# FREDERICK COUNTY PLANNING COMMISSION May 11, 2016

TITLE: Bennett Preserve (Formerly Crossroads)

FILE NUMBER: S-1131, AP 15582 (APFO 15583, FRO

REQUEST: Preliminary Plan Approval

Graphic # 2: Previous approved Crossroads Subdivision S-1131 AP 13001

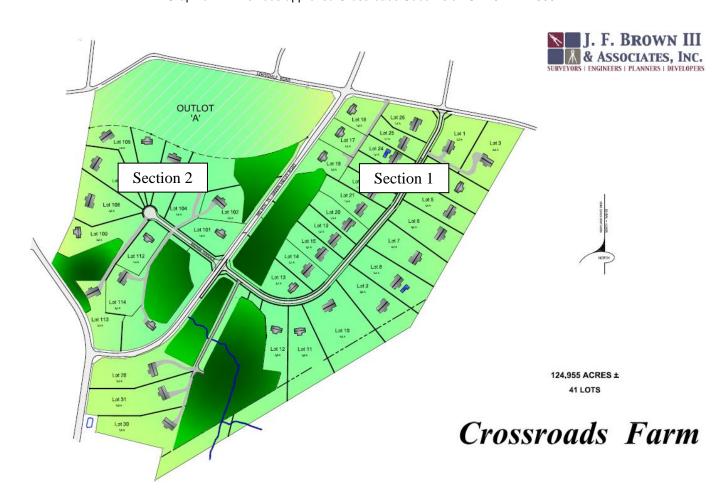
On November 13, 2013 the Frederick County Planning Commission (FCPC) conditionally approved Crossroads Farm Preliminary Subdivision Plan AP 13001 for 41 single family residential lots on 124.95 acres, comprised of Section 1 and 2 located on both sides of MD 75 (See Graphic #2 Crossroads Preliminary Plan Rendering below). Due to design constraints the Applicant removed 2 lots within Phase 3 on the final design prior to final signature and 39 lots were approved. Section 2 is not part of the current Bennett Preserve preliminary plan amendment application review.

Graphic #4: Bennett Preserve Zoning Map

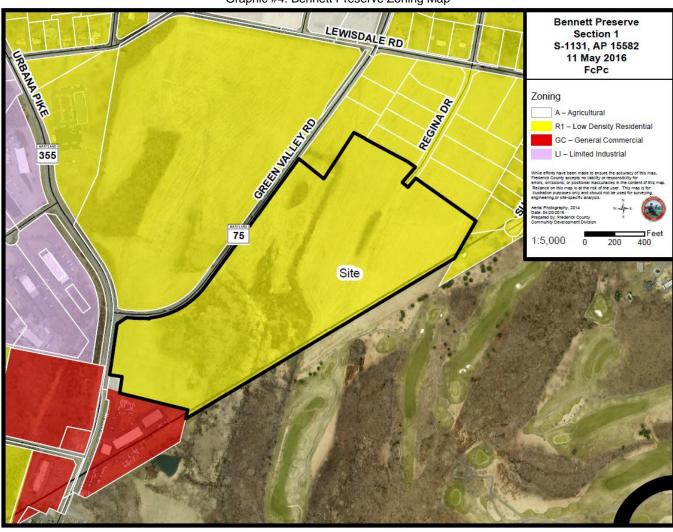
The site is zoned R1 residential (see Graphic 4 below) and consists of open agricultural ground, with forested corridors along the eastern and western boundaries of MD 75, see Graphic #2 below. Thirteen lots in Section 1 have been recorded and are under construction. Stream valleys cross the southern portion of the site. The site adjoins the Sugarloaf Vista residential subdivision to the east, located off of Sugar Loaf Park View Lane.
